CHANGE ORDER NO. 15 City Number

Contractor Name.: **Security Paving Co., Inc.**
 Project Title: **Hwy. 101 at Rice Ave. Interchange (ESPL 5129(058) & HPLUL 5129(063))**
 Specification No.: **PW03-19** Account No.: 210-9718-826-8605 Project No.: **873114** \$122,646.25
 Contract No.: **A-7228** Account No.: **275-9063-826-8604** Project No.: **873114** \$122,646.25
 P.O. No.: **3514/3515/3516/3517** Account No.: Project No.:
 Fed. Proj. No.: Account No.: Project No.:
 STPL 5129(012), HPLUL 5129(051,056,063) Account No.: Project No.:
 TILUL 5129(057), ESPL 5129(058) Account No.: Project No.:
 Total \$245,292.50

CCO NUMBER 15	SUPL. NUMBER 0	CONTRACT NO. PW03-19	ROAD HIGHWAY 101 at RICE AVE.	FEDERAL NUMBER(S) STPL-5129(012), ESPL5129(058), HPLUL-5129(051), HPLUL-5129(056), TILUL-5129(057)
------------------	-------------------	-------------------------	----------------------------------	---

This change is generally described as follows: Due to concerns with settlement affecting existing utilities, remove embankment fill material from the "R" alignment. This area shall remain free of embankment fill until such time as the Engineer deems necessary. The removed material shall be replac

STA. 97+98 to 99+10, "R" ALIGNMENT.

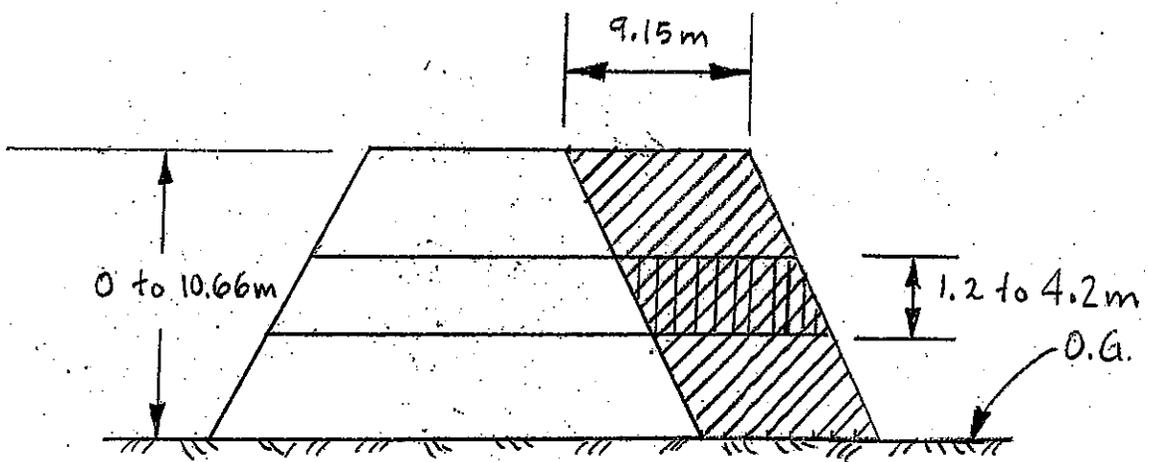
As shown on sheet two of this change order, and as directed by the Engineer, provide all labor, equipment, materials, tools and incidentals to remove embankment fill material from Station 97+98 to Station 99+10, "R" alignment, Rt.

In accordance with Section 10-1.34, "Material Containing Aerially Deposited Lead," of the Special Provisions, and as directed by the Engineer, provide all labor, equipment, materials, tools and incidentals to remove, stockpile, and replace aerially deposited lead material from the embankment fill shown on sheet two of this change order. The material which shall be considered as containing aerially deposited lead is located between Stations 98+05 and 99+10 and from elevation 25.4m to 27.7m, as shown on sheet two of this change order.

ESTIMATED SETTLEMENT CONTOUR MAP

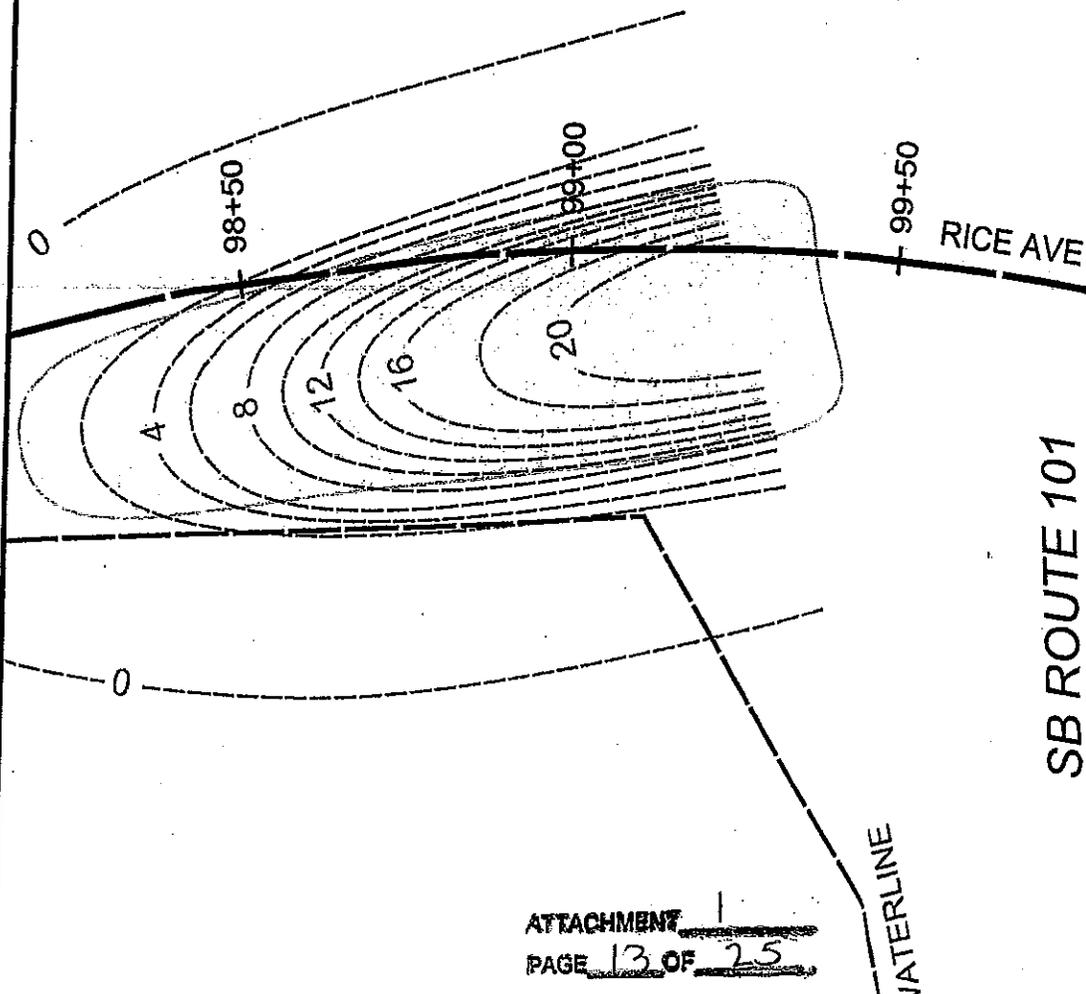
- Sheet-1: Estimated settlement contour map based on the embankment limits and X-sections shown in Sheets 3 and 4. The contour values are approximately 90% of consolidation settlements (primary consolidation).
Sheet-2: Estimated settlement contour map for the settlements occurred as of 06/24/10, which is about 50 to 60% of the primary consolidation settlements.
Sheet-3: The limits of the existing embankment from AECOM
Sheet-4: The X-sections of the existing embankment from AECOM/URS.

**ESTIMATED SETTLEMENT
AS OF 6-24-10 CONTOUR MAP**

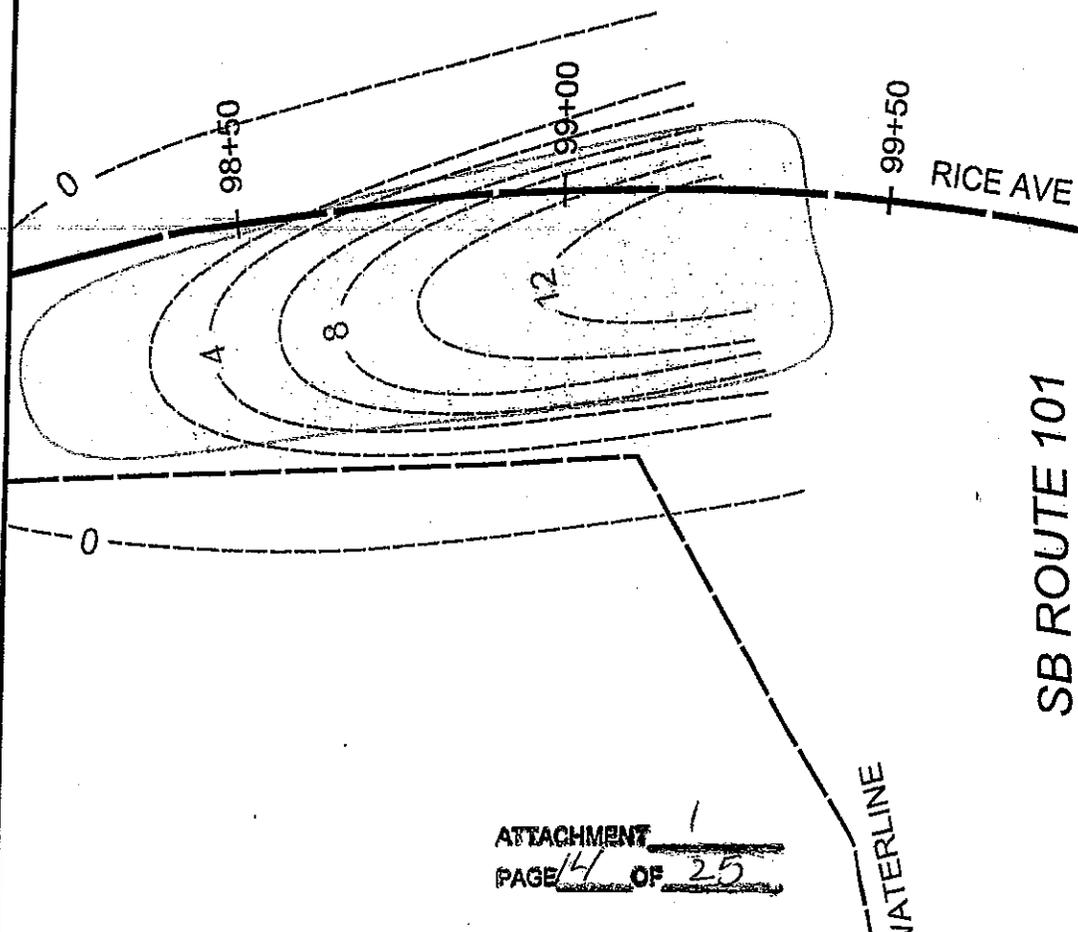
Sheet-2: Estimated settlement contour map for the settlements occurred as of 06/24/10, which is about 50 to 60% of the primary consolidation settlements.

Embankment c/s along SB on-ramp
(in proximity of 45" waterline)

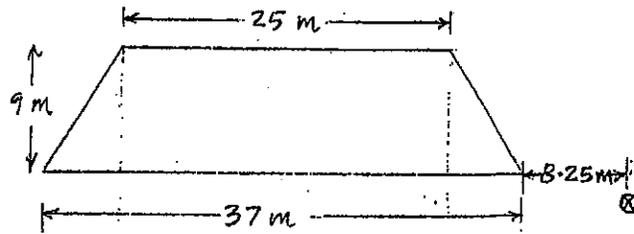
Note that the X-sections show an embankment slope at 1.0H:1.5V which is much steeper than we assumed for our previous calculations (assumed the slope of 1.5H:1V). As a result, the estimated settlement as of June 24, 2010 is greater than what we estimated previously. I suspect a little bit of the slope gradient. Typically, it does not allow such a steeper temporary slope unless a slope stability analysis is performed with satisfactory FOS. I suggest the embankment limits and X-sections (Sheets 3 and 4) be double checked by AECOM/URS.

3

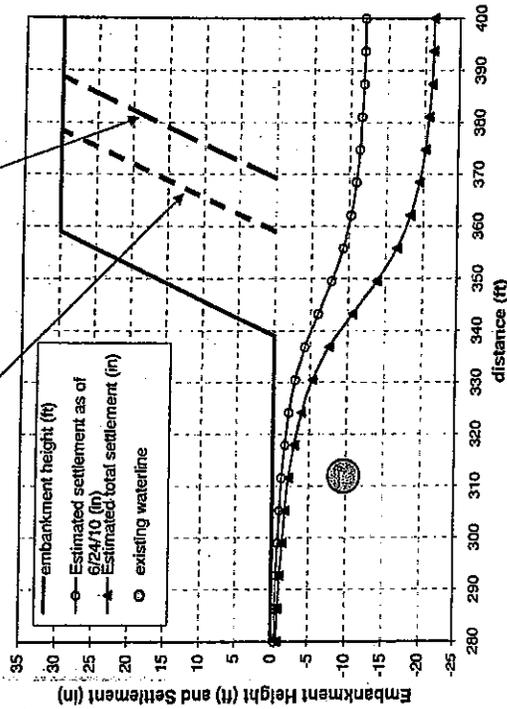
Removal for FS=1.0 is approximately 20 feet

Removal for FS=1.5 is approximately 30 feet

In addition to what I sent to you last Friday 7/9/10, I added the settlement summary tables and recommended removal limits in the attached results. As you may see, in order to keep the settlement along the 45-inch waterline alignment no longer increase, the minimum removal with a factor of safety (FS) of 1.0 is approximately 20 feet. We recommend a removal of 30 feet which has a FS of 1.5. Our recommended removal limits are marked in red on Plates 3 through 7.

Plate 7

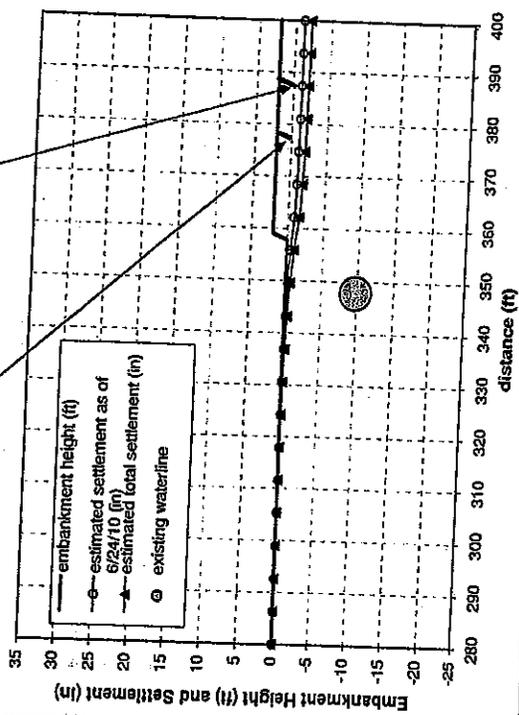
Removal for FS=1.0 is approximately 20 feet

Removal for FS=1.5 is approximately 30 feet
